**Addendum for Invitation for Bids
LCS Paul Munro Elementary School Window Replacement Phase 2**

ADDENDUM #1

Name of Project: Lynchburg City Schools Paul Munro Elementary School Window
Replacement – Phase 2
Location: Lynchburg, VA
Project No.: 3210
Date: January 7, 2014

SKETCH NO.: AX-1

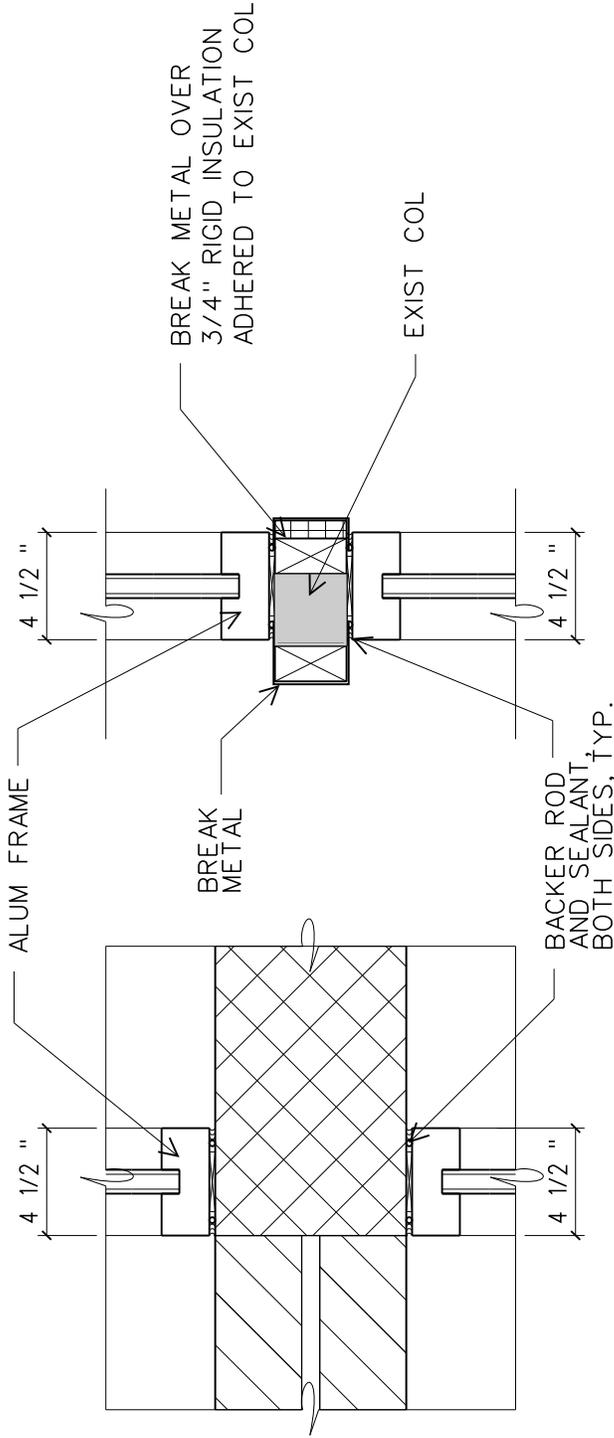
Sheet A9.2 – Head, Jamb & Sill Details:

Please refer to attached Sketches AX-1 and AX-2 for changes to the head, jamb and sill details.
